UNITED STATES PATENT AND TRADEMARK OFFICE

APPLICATION NO.	FILING DATE	FIRST NAMED INVENTOR	ATTORNEY DOCKET NO.	CONFIRMATION NO.
10/667,954	09/22/2003	Enzo Berti	06387.00037	1212

Office Action Summary

DETAILED ACTION

Robertson (USPN D468106, figure 1)

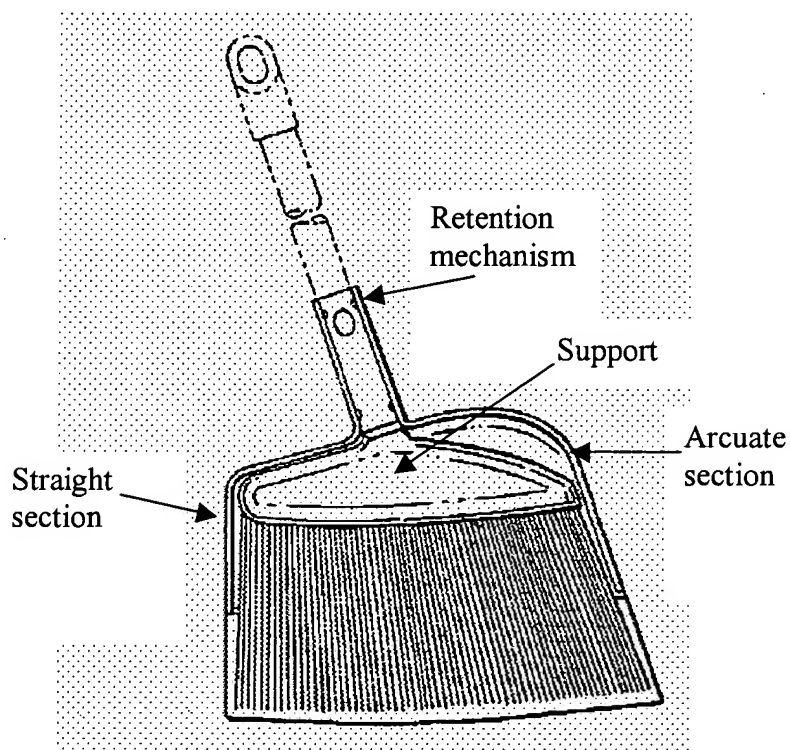
Robertson teaches a dustpan and broom kit. The dustpan includes a tray with a leading edge and retention rib opposite the leading edge (claim 1). There is a handle connected to the retention rib and the handle is formed at a *generally* right angle with the leading edge (claim 1). The handle includes a broom handle cavity and a retention mechanism for receiving and retaining a broom handle (claim 1). The tray is bounded by the retention rib and the rib defines an arcuate circular arc section extending from one side of the leading edge and a substantially straight section extending from the other side of the leading edge (claim 3). The arcuate section of the retention rib engages the straight section at an intersection adjacent a side of the dustpan handle (claim 4). The broom has a broom handle with a bristle support attached to one end of

the handle (claim 1). The support has a top side attached to the handle and bottom side with bristles projecting from the bottom side (claim 1). The bristles define a sweeping plane and the broom handle axis and the sweeping plane form an obtuse angle (claim 1). The broom handle is engageable with the broom handle cavity on the dustpan (claim 1). The dustpan handle projects from an end of the arcuate section opposite the leading edge and at a position intermediate the ends of the arcuate section (claims 6, 7).

Robertson teaches all the essential elements of the claimed invention however, the reference fails to teach that the rib defines a continuous arcuate section extending from one side of the leading edge to the handle (claim 1). At the time the invention was made, it would have been obvious to a person of ordinary skill in the art to use a continuous arcuate section because Applicant has not disclosed that a continuous arcuate section provides an advantage, is used for a particular purpose, or solves a stated problem. One of ordinary skill in the art, furthermore, would have expected Applicant's invention to perform equally well with the arcuate section as taught by Robertson or the claimed continuous arcuate section because both arcuate sections perform the same functions of facilitating movement of dust or trash along its periphery by action of the broom bristles and funneling trash equally well. Therefore, it would have been obvious to one of ordinary skill in the art to modify Robertson to obtain the invention as specified in claim 1.

Robertson teaches all the essential elements of the claimed invention however, the reference fails to teach an angle of 50-75 degrees between the leading edge and the straight edge (claim 2). At the time the invention was made, it would have been obvious to a person of ordinary skill in the art to provide an angle of 50-75 degrees between the leading edge and the

straight edge because Applicant has not disclosed that an angle of 50-75 degrees provides an advantage, is used for a particular purpose, or solves a stated problem. One of ordinary skill in the art, furthermore, would have expected Applicant's invention to perform equally well with either the angle as taught by Robertson or the claimed 50-75 degree angle because both configurations allow for proper collection and disposal of waste.
